MAY 03, 2010

ADDENDUM 4

Project: NMHU Student Union Building

From: Studio Southwest Architects

MECHANICAL HVAC FIRST LEVEL CEILING PLAN

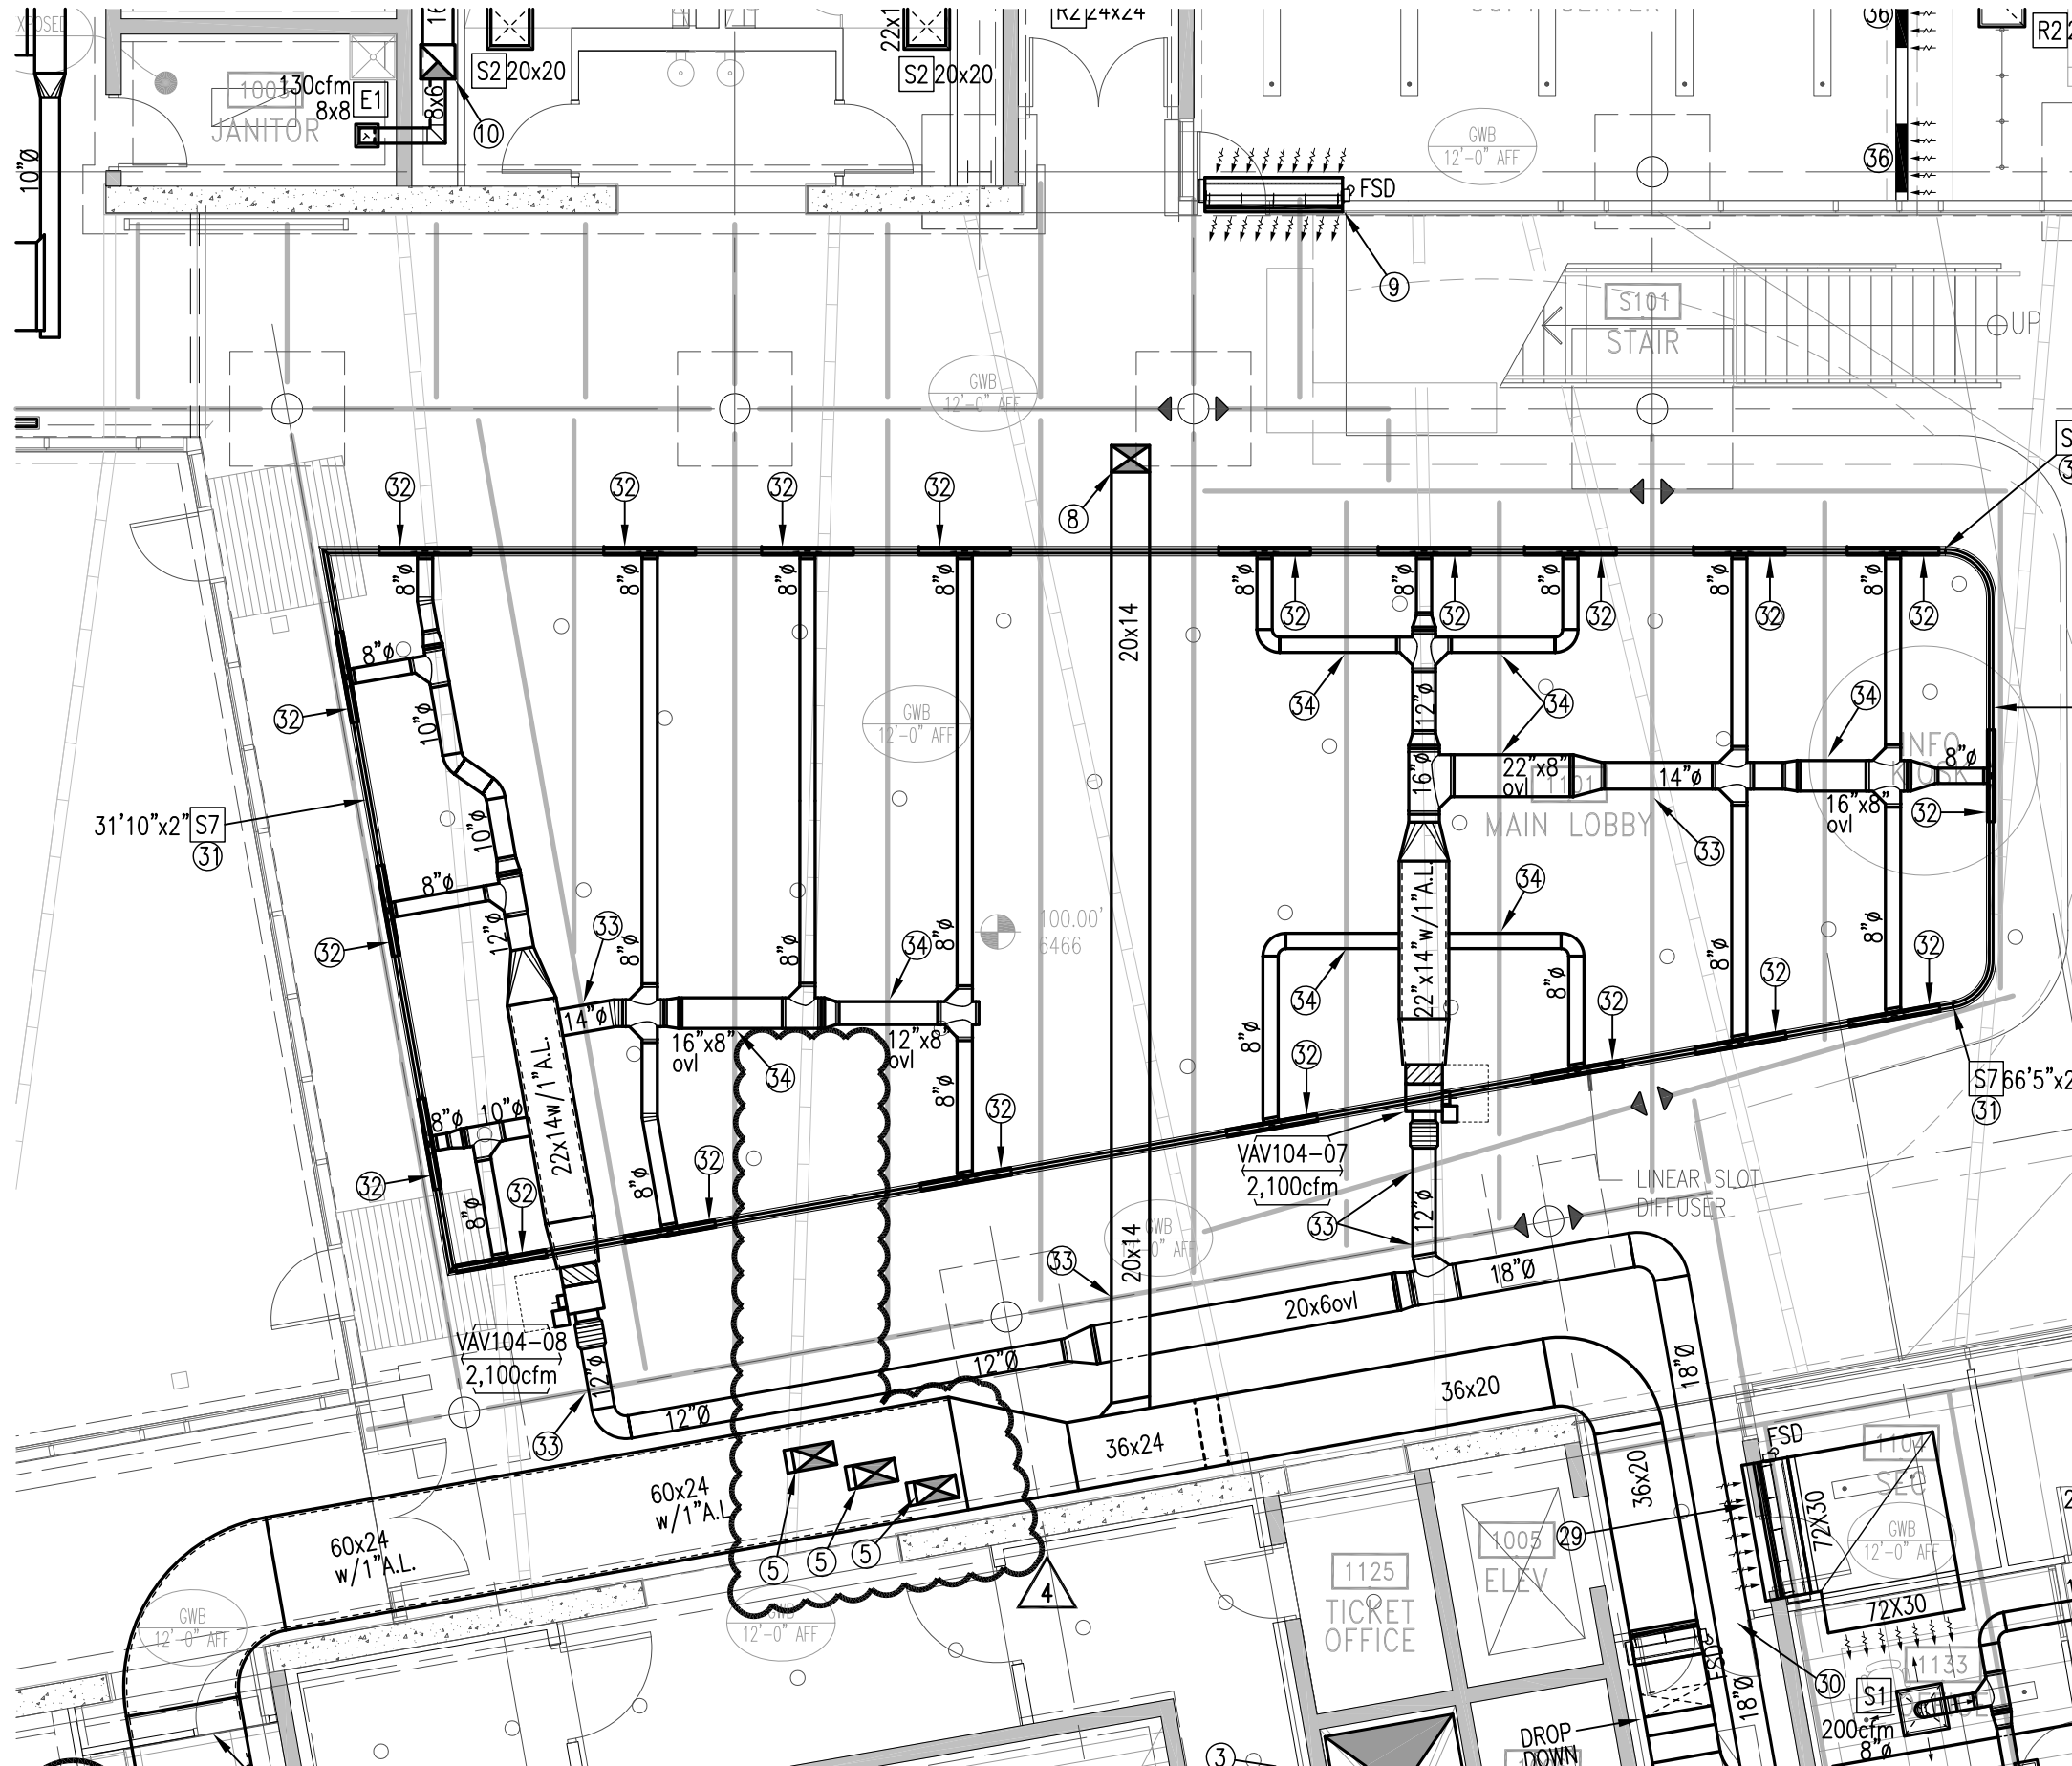
- **Revise** ductwork serving 2nd floor level per SK5.

MECHANICAL HVAC SECOND LEVEL FLOOR PLAN

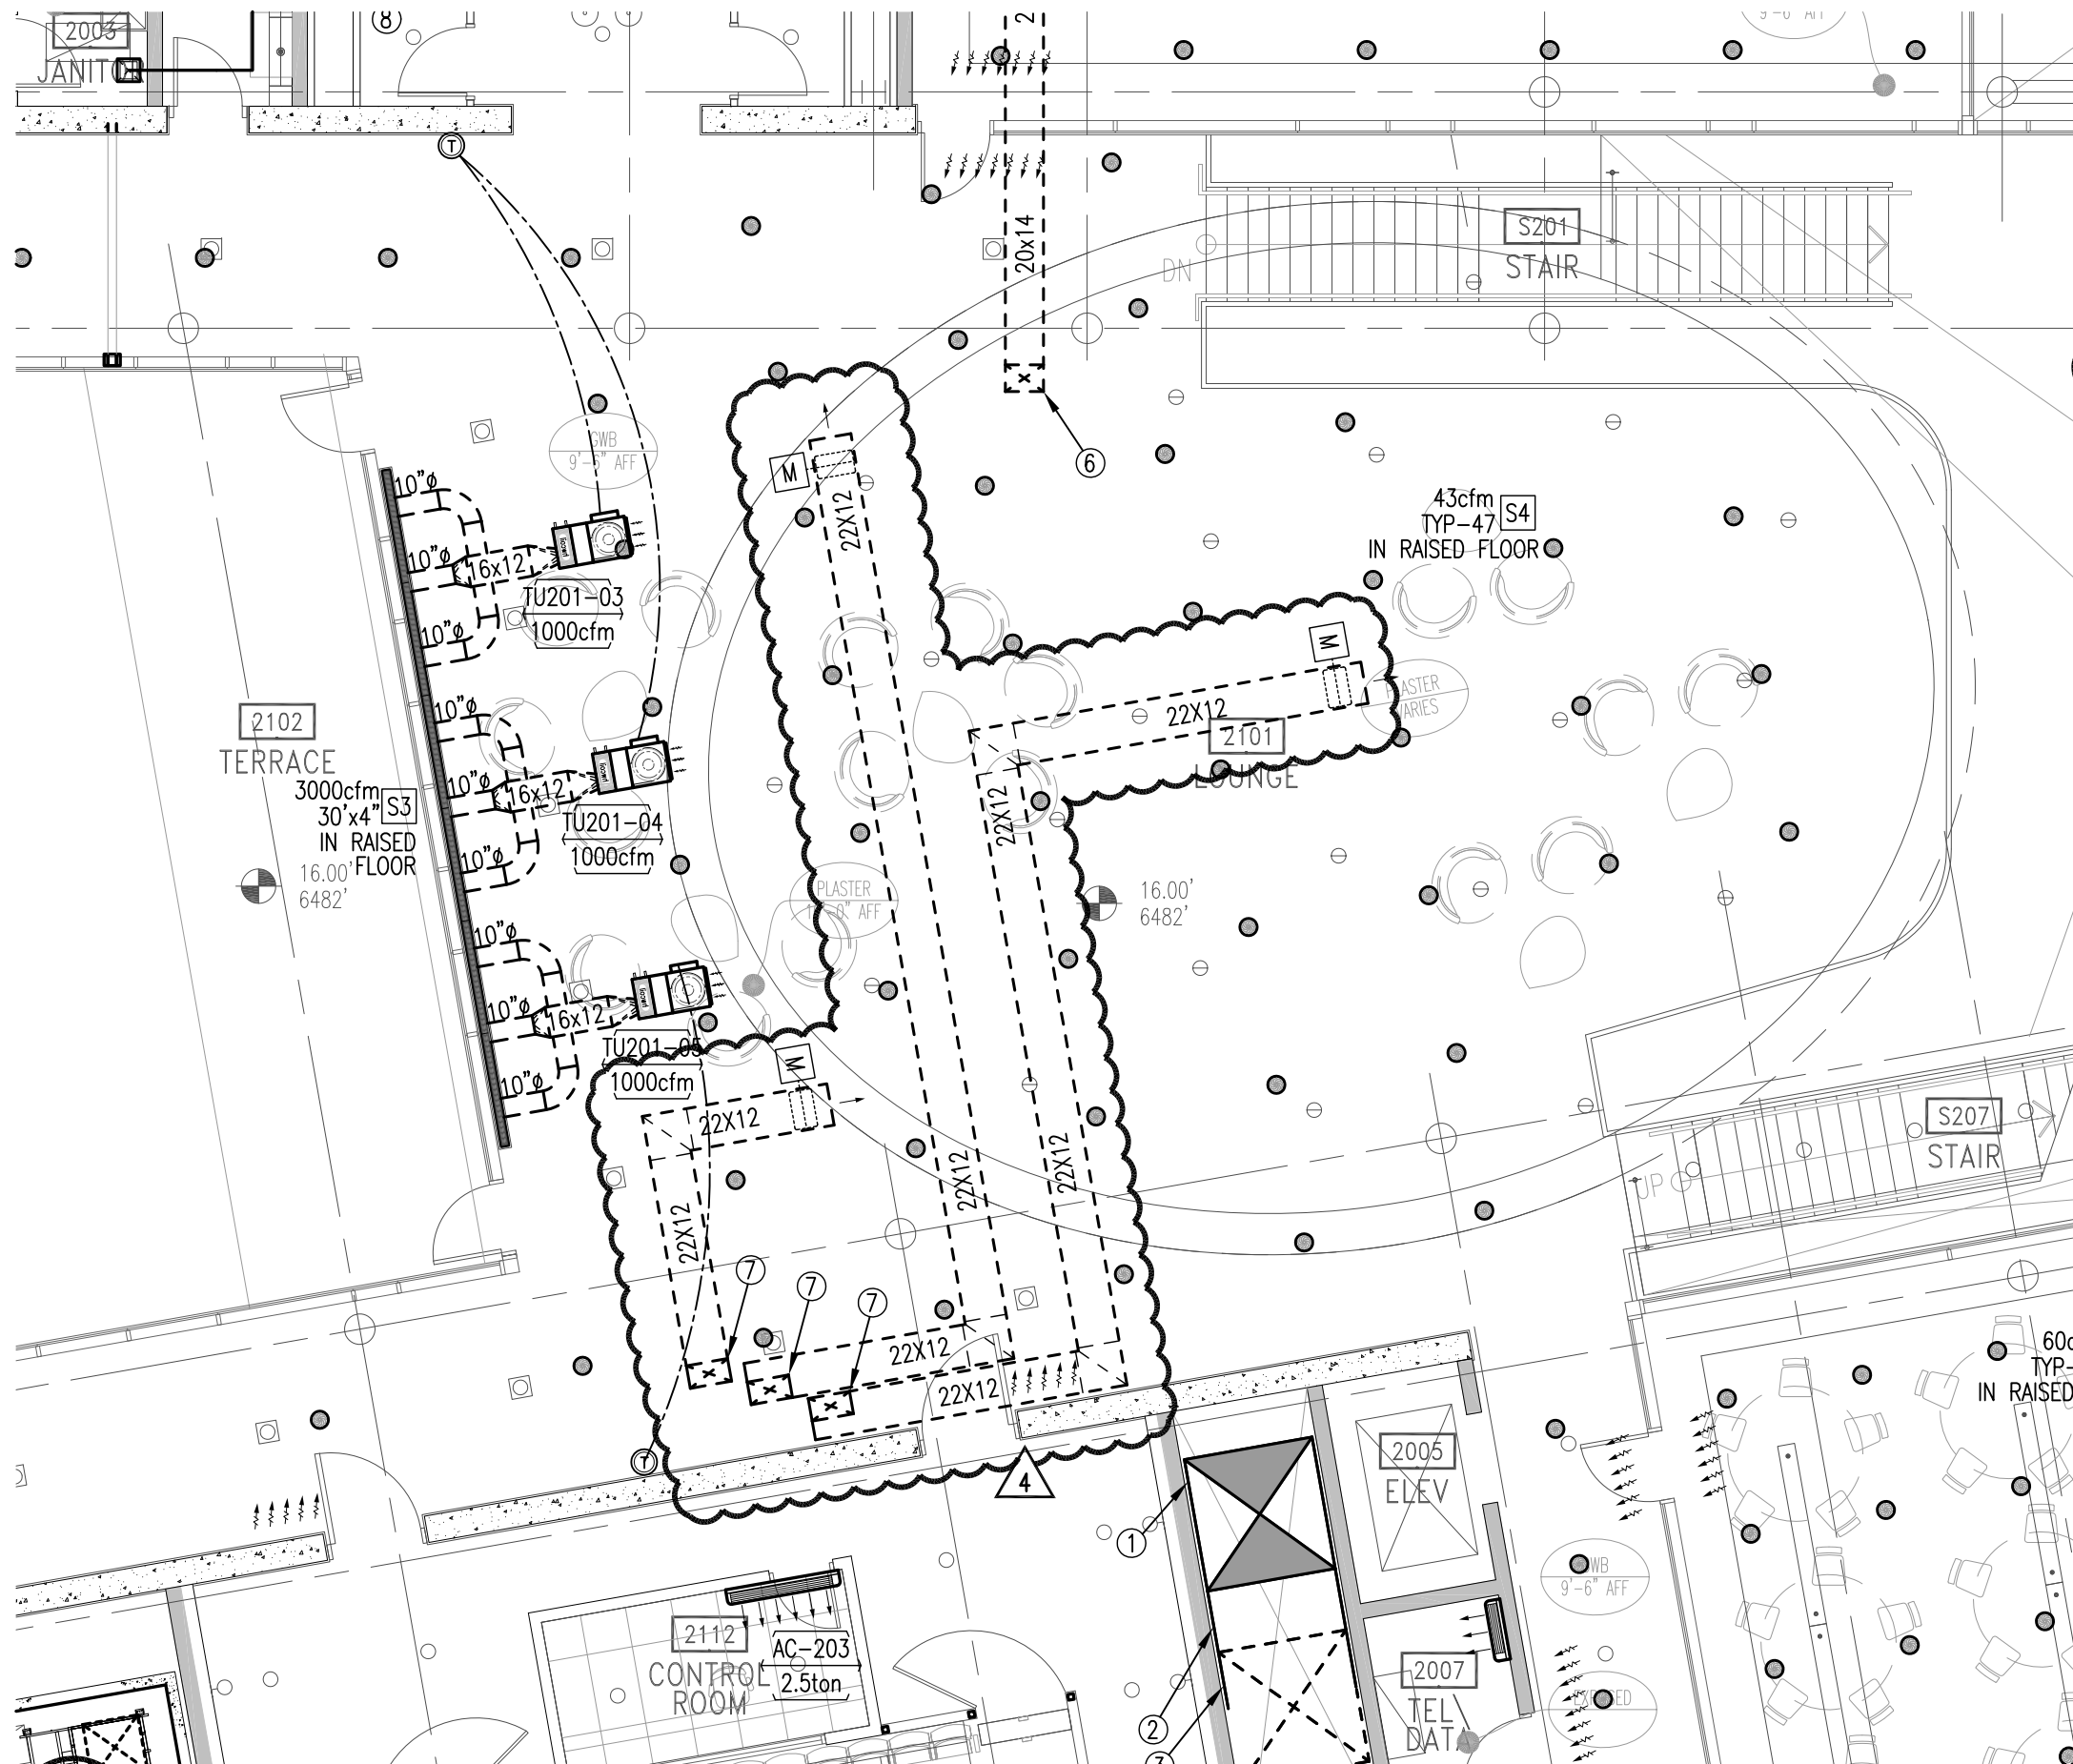
- **Revise** ductwork serving 2nd floor level per SK6.
